# CITY PLAN COMMISSION STAFF REPORT

November 1, 2022

ArriveKC

CD-CPC-2022-00123  
Rezoning  
Major Plan Amendment

**SP1.00**

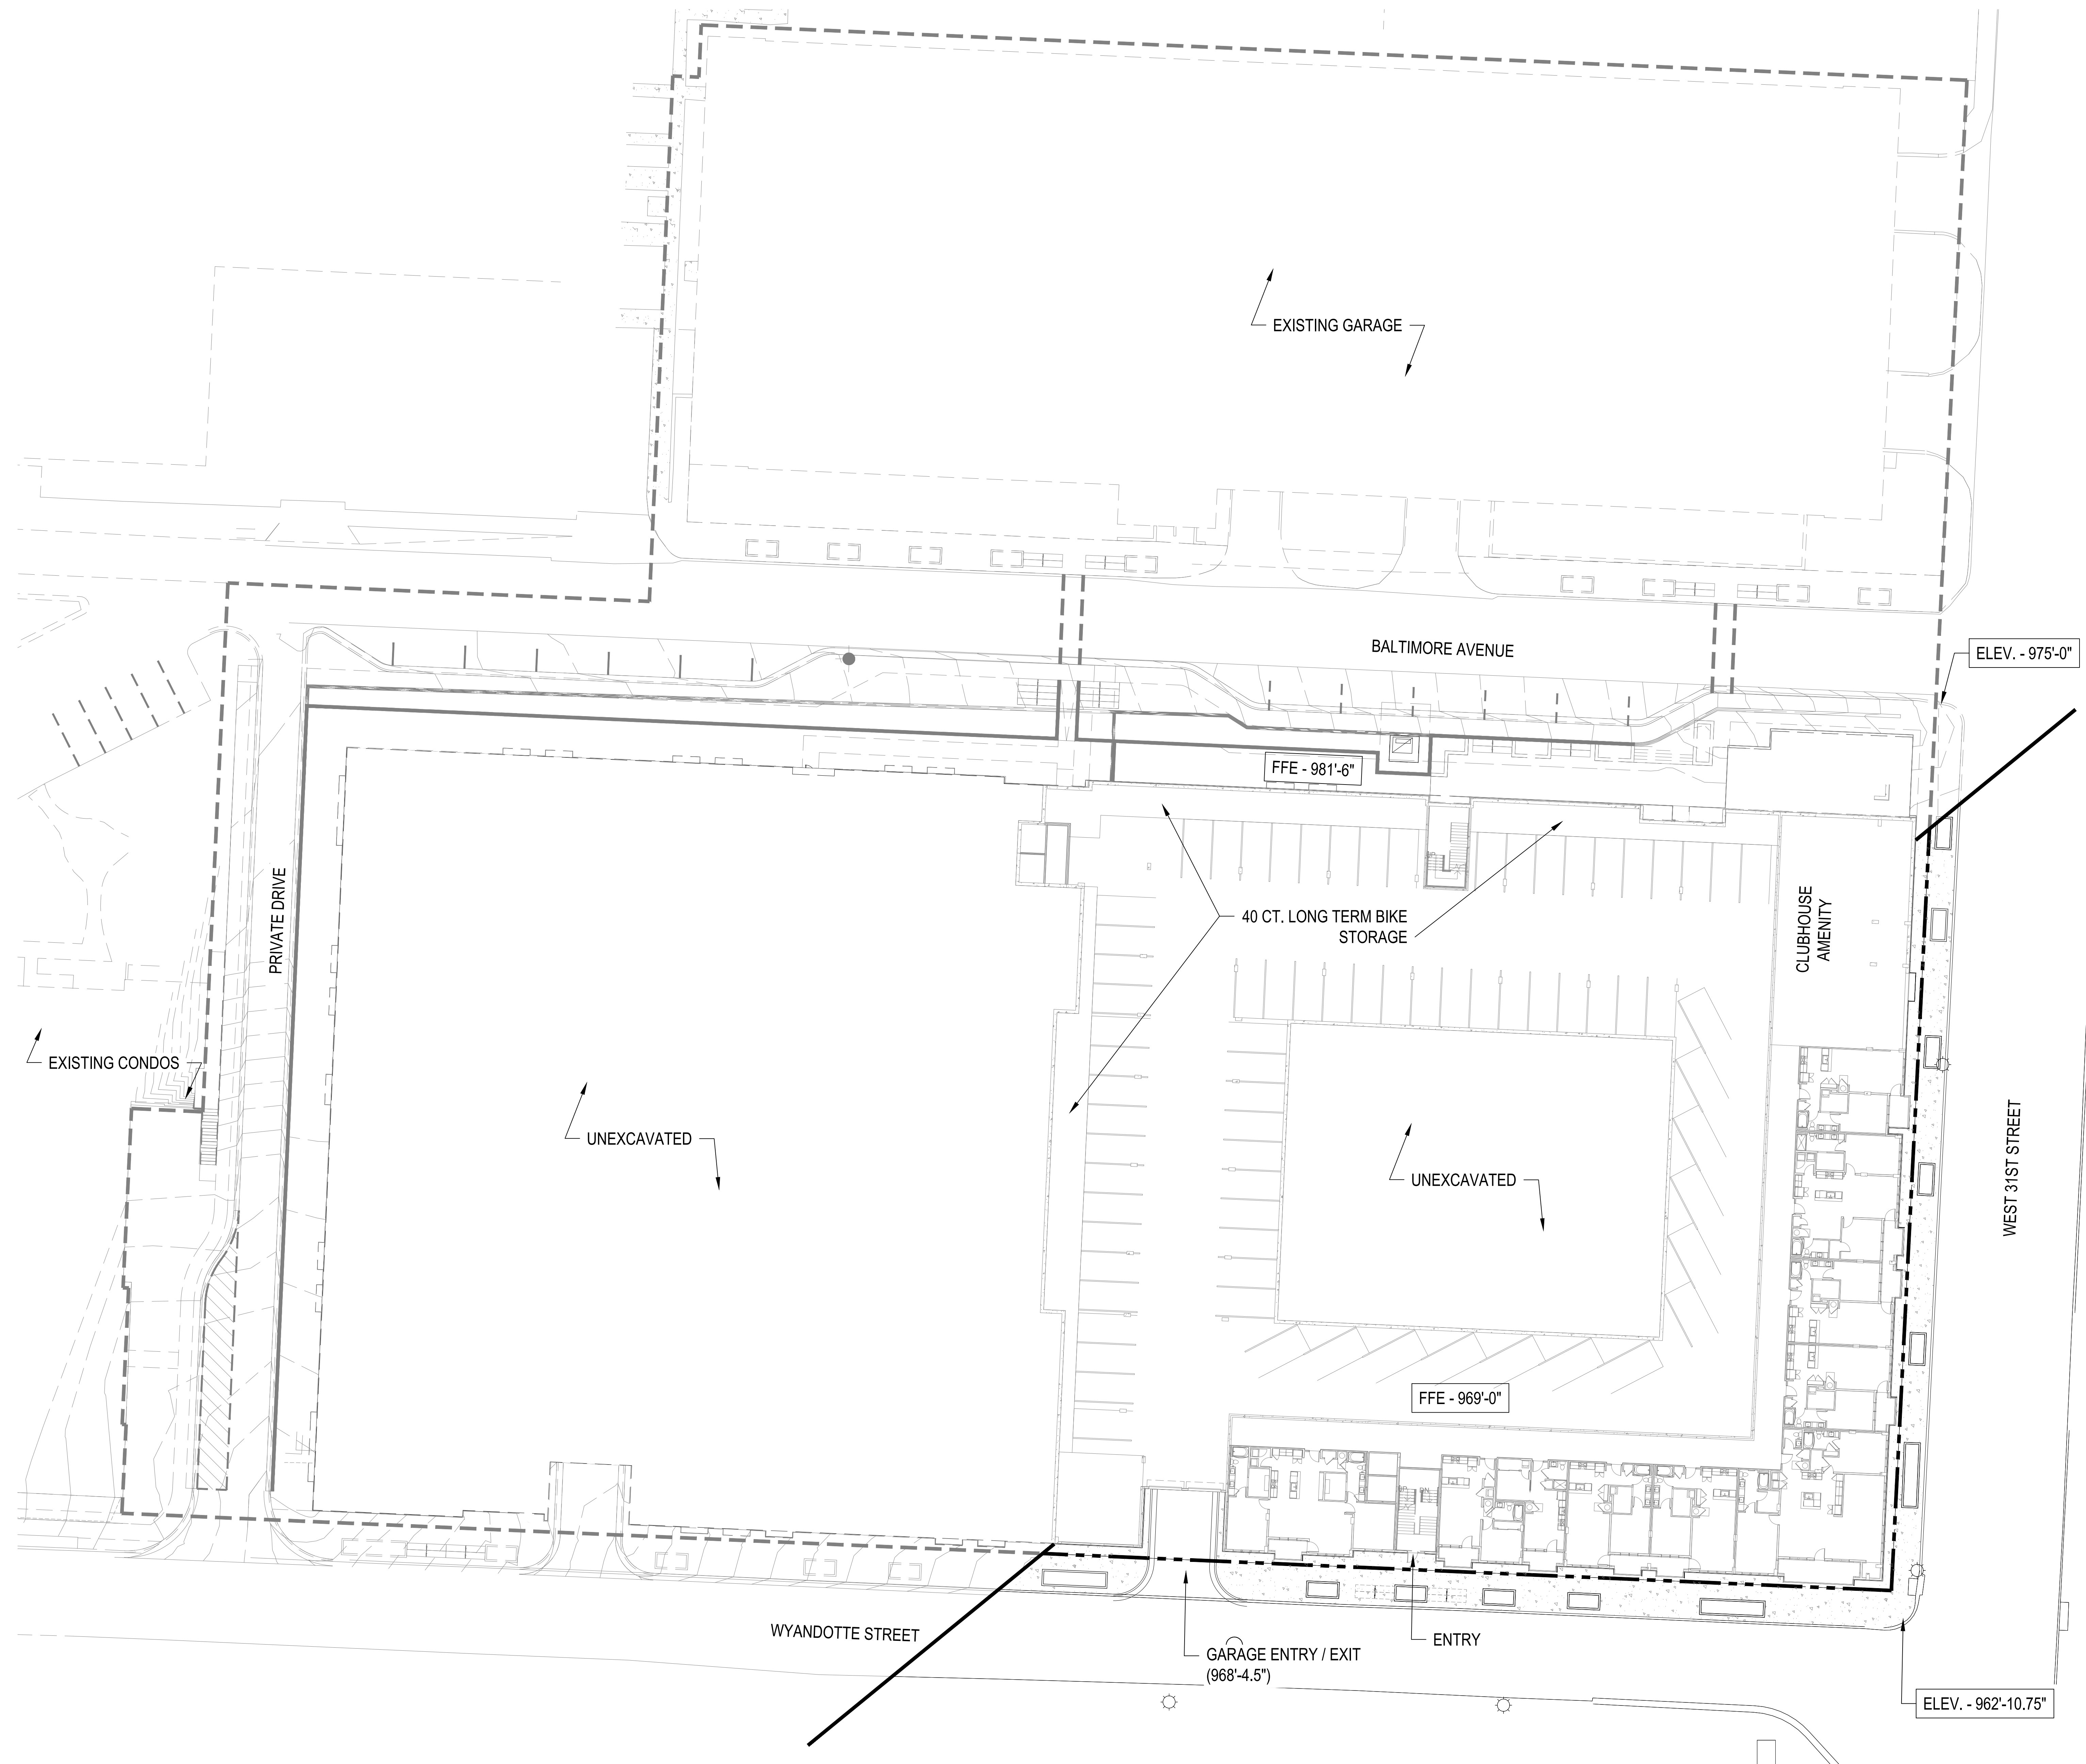
2. That Ordinance No. 080217, including all conditions provided therein, shall remain in full force and effect.
3. That the plan is revised to show short-term bicycle parking as required of 88-420-09.

4. That the plan is revised to show long-term bicycle parking as required of 88-420-09.
5. The developer shall submit an affidavit, completed by a landscape architect licensed in the State of Missouri, verifying that all landscaping required of the approved plan has been installed in accordance with the plan and is healthy prior to Certificate of Occupancy.

**LONG TERM:**  
REQUIRED - 1 PER 3 DWELLING UNITS  
373 / 3 = 125 SPACES REQUIRED  
PROVIDED: 125 SPACES WITHIN GARAGE INTERIOR - SEE ARCH. PLANS
